This application is for the following scope of amendments:

1. Clarify internal contradictions in CofA pertaining to stair bulkhead to address Notice of Violation; application is for as-built bulkhead to remain
2. Add a safety rail at north end of roof, not visible from street
3. Add an enclosure for fresh air intake at front areaway

Also shown: documentation of corrective work to address Notice of Violation

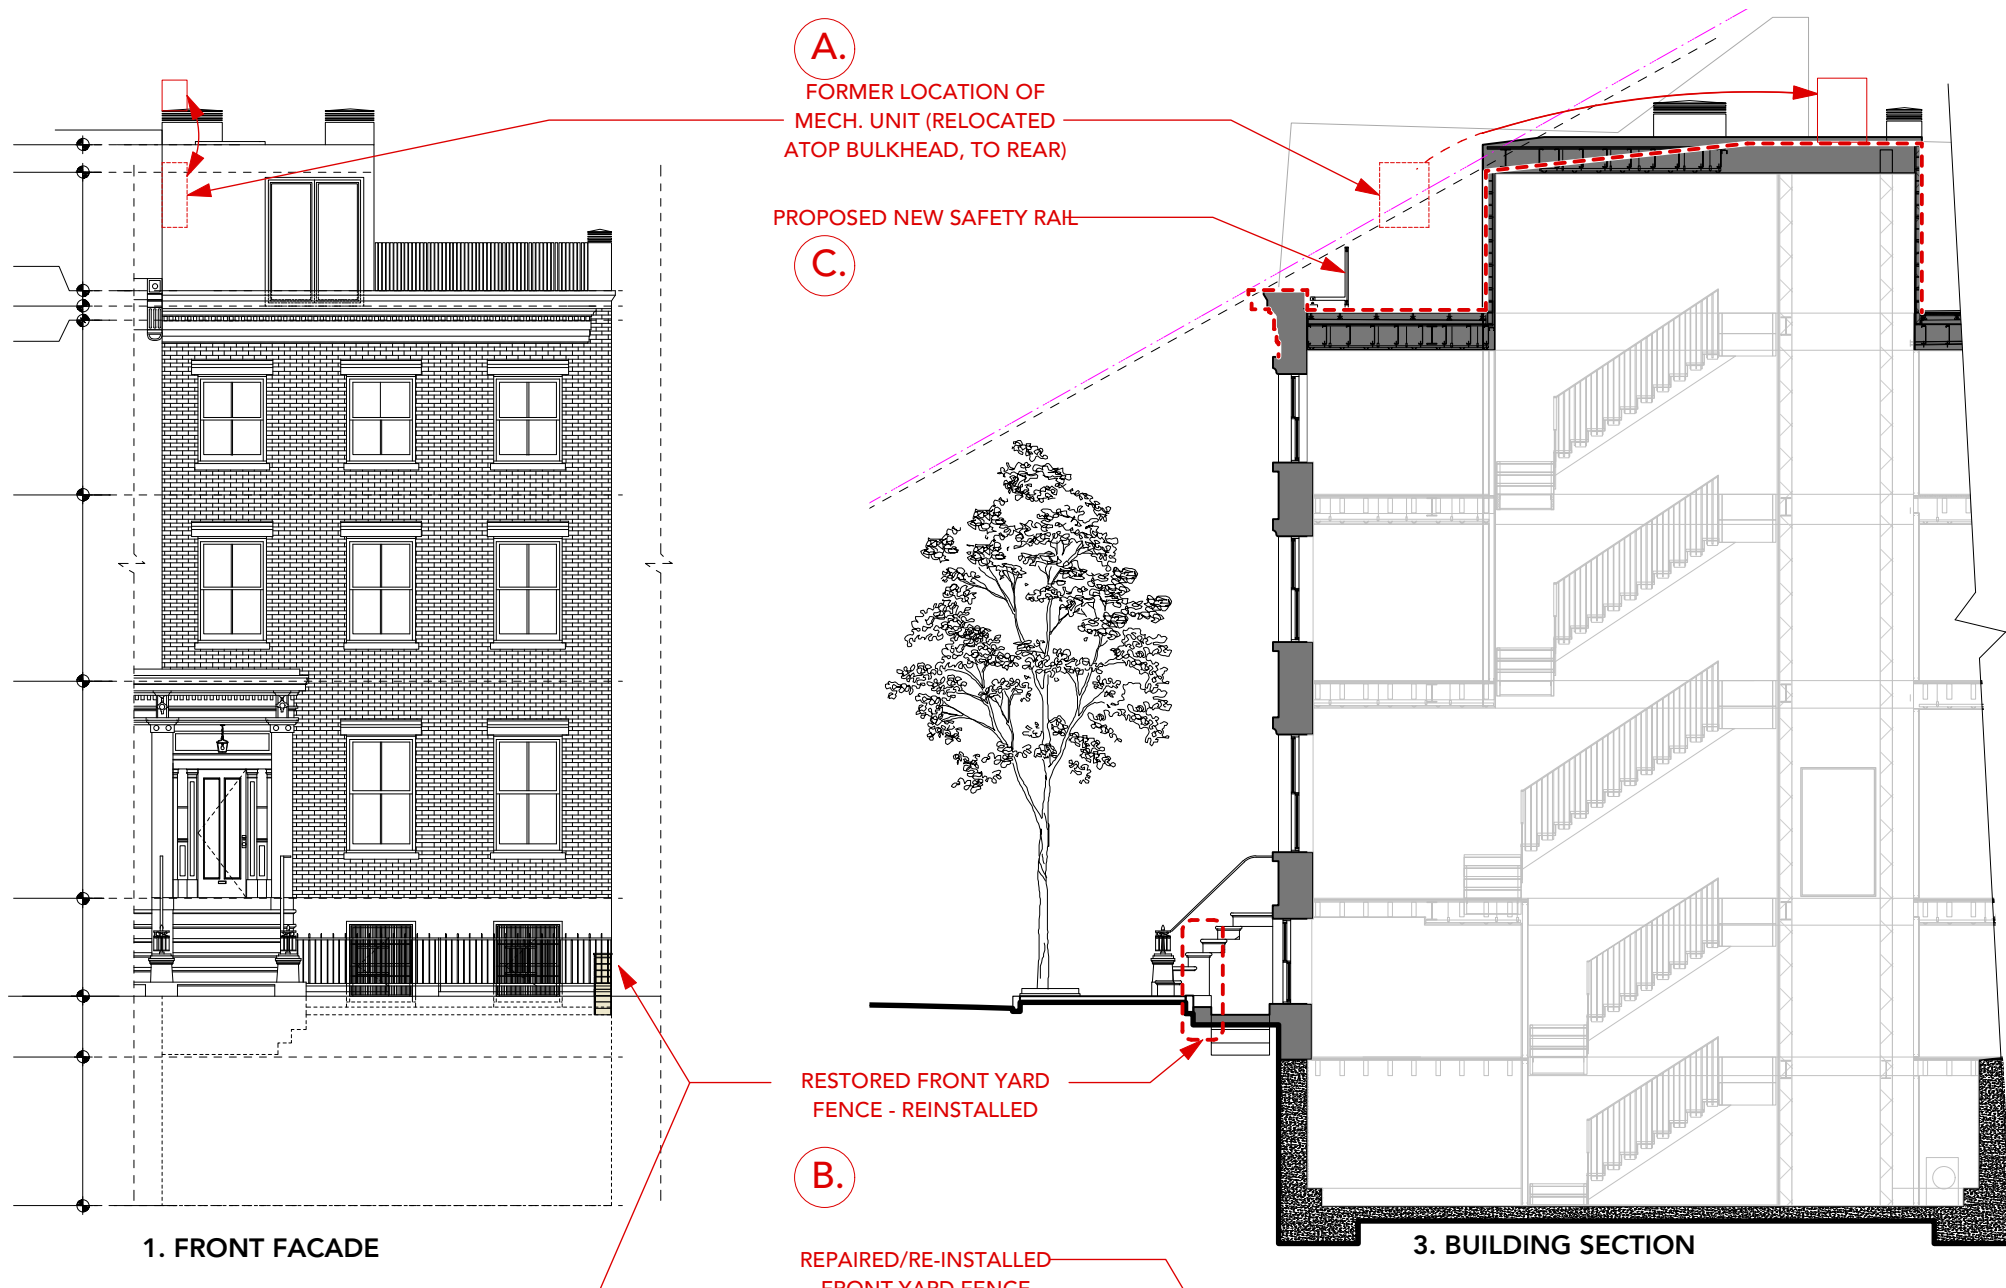
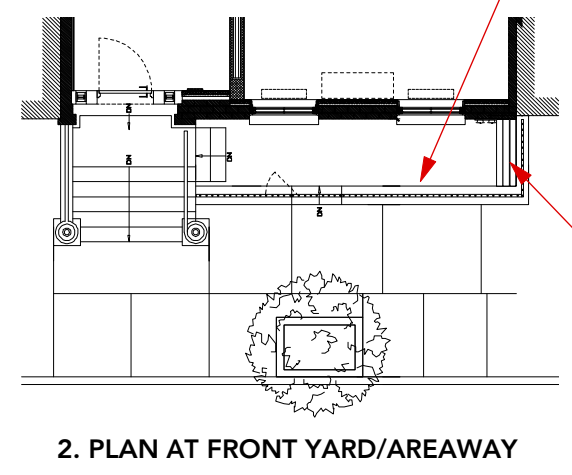
- A.** Notice of Violation mentions the air conditioning unit visible from the street; this has been relocated to the roof of the bulkhead, no longer visible from the street. (see (A), this sheet.)

- B.** Notice of Violation mentions the railing at the front areaway; this was in the process of being repaired, it is presently returned to the site. (see (B), this sheet.)

- D.** Approved Mechanical drawings show fresh air intake at front areaway; approved elevations omitted the enclosure for these ducts. We respectfully request permission to build an Ipe (wood) enclosure at the location shown along the west lotline, with top of enclosure at 2'-4" max. above sidewalk level. (see (D), this sheet)

**B.** RESTORED FRONT YARD FENCE - REINSTALLED

**D.** PROPOSED NEW FRESH AIR INTAKE; IPE ENCLOSURE TO MINIMAL HT. REQUIRED PER HVAC CODE. TOP OF ENCLOSURE AT 2'-4" ABOVE SIDEWALK LEVEL

**A.** RELOCATED MECH. UNIT - (NOT VISIBLE IN PHOTO, OUT OF LINE OF SIGHT FROM STREET)
